### **3.8 Traffic and Transportation**

**Comment 3.8-1. (Letter From John L. Sarna, November 22, 2011).** At your request I have reviewed for technical content the Traffic Section of the Draft Environmental Impact Statement for the proposed Raleigh and Heiden Properties development, dated October 13, 2011, prepared by Tim Miller Associates, Inc. This review follows my Review for Completeness of the original submission dated June 20, 2011, and my memos of August 16, 2011, and October 4, 2011.

**Figure 3.8-1: Regional Context**  
**Raleigh and Heiden Properties**  
 Town of Fallsburg  
 Sullivan County, New York  
 Base Map: NYS DOT Planimetric Map  
 Scale: As shown

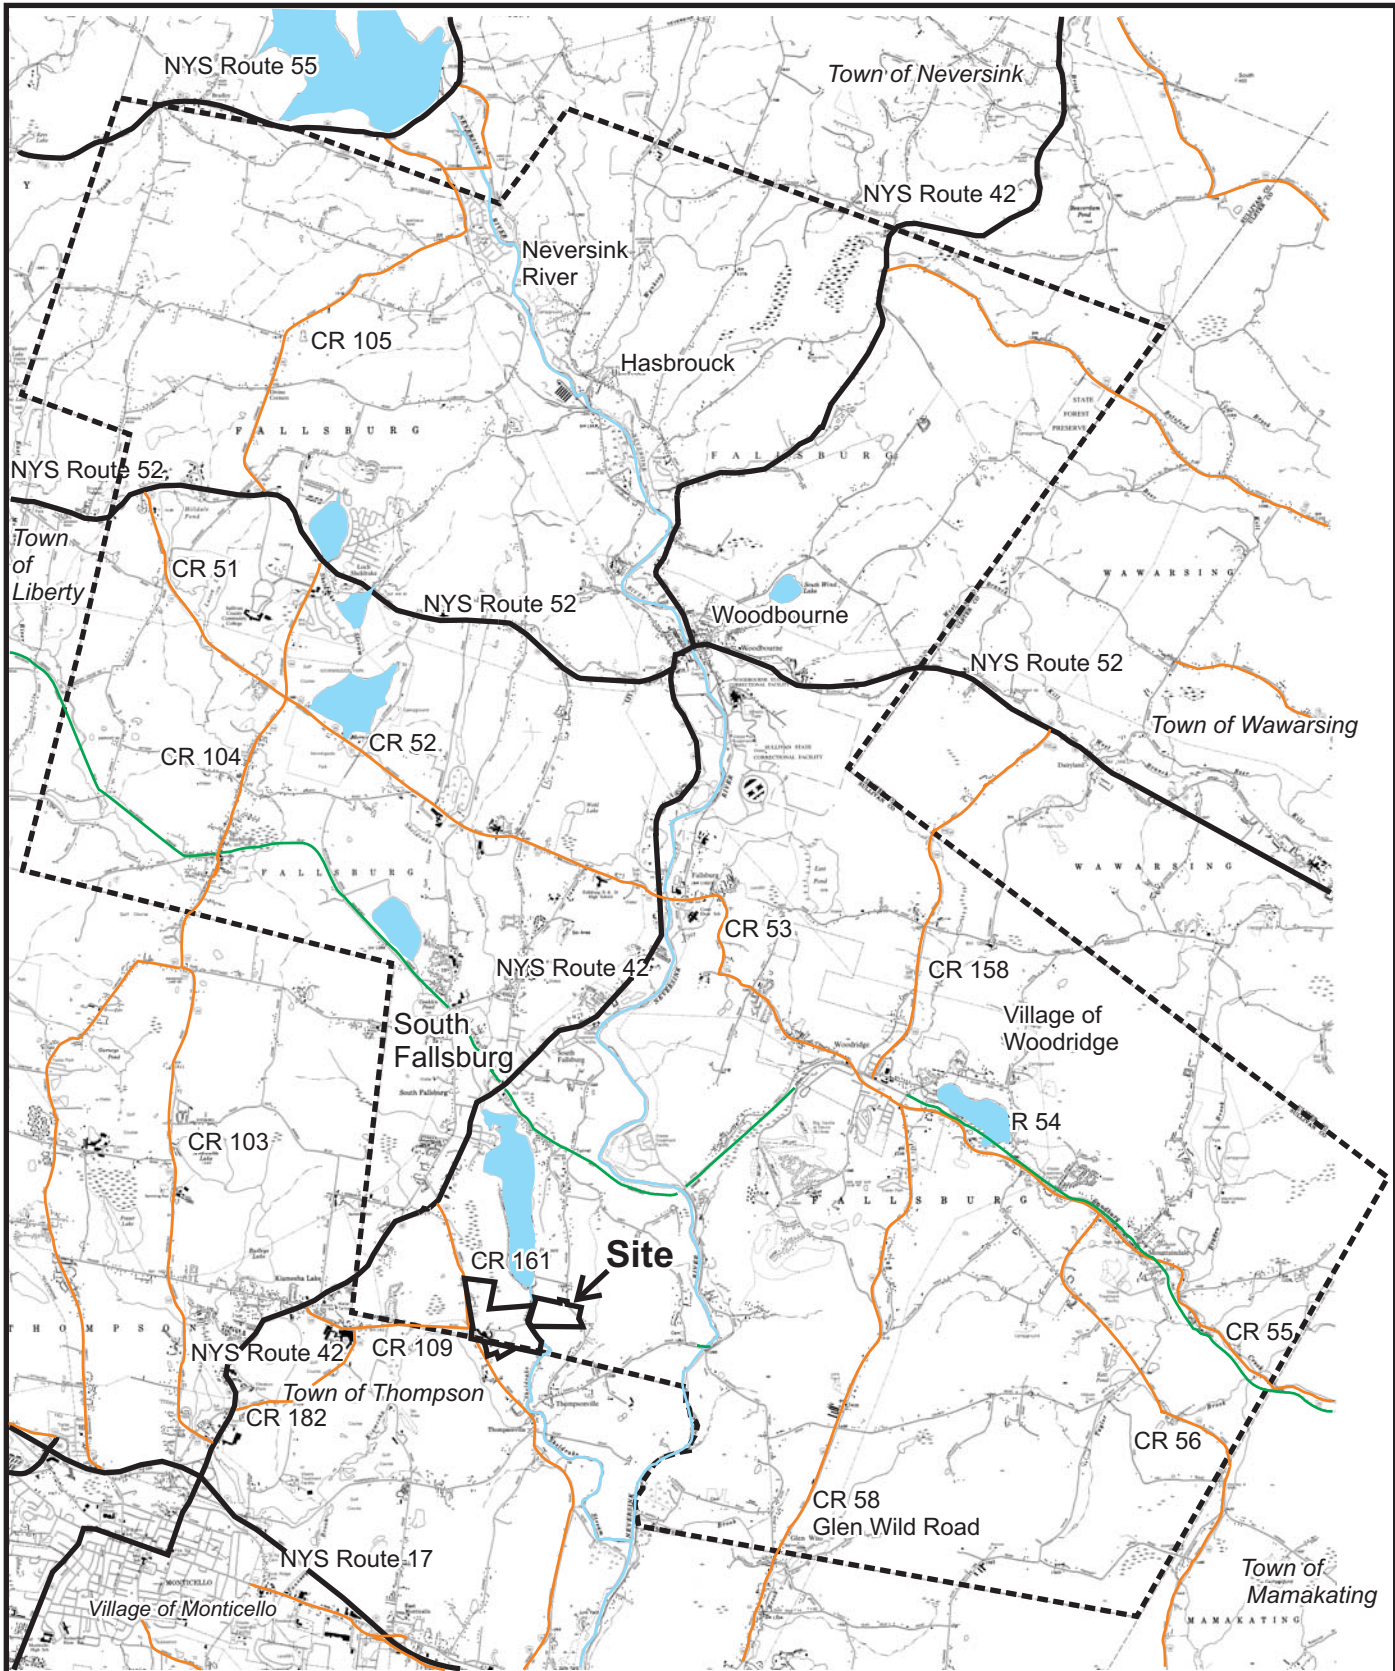
**Comment 3.8-6. (Letter From John L. Sarna, November 22, 2011).** Tim Miller Associates

has revised Figure 3.8-1 to show the locations of the other developments, and this revised figure should be included in the FEIS.

**Response 3.8-6:** *Mr. Sarna was provided with a revised Figure 3.8-1 and this FEIS Figure 3.8-1 is contained in Appendix C.*
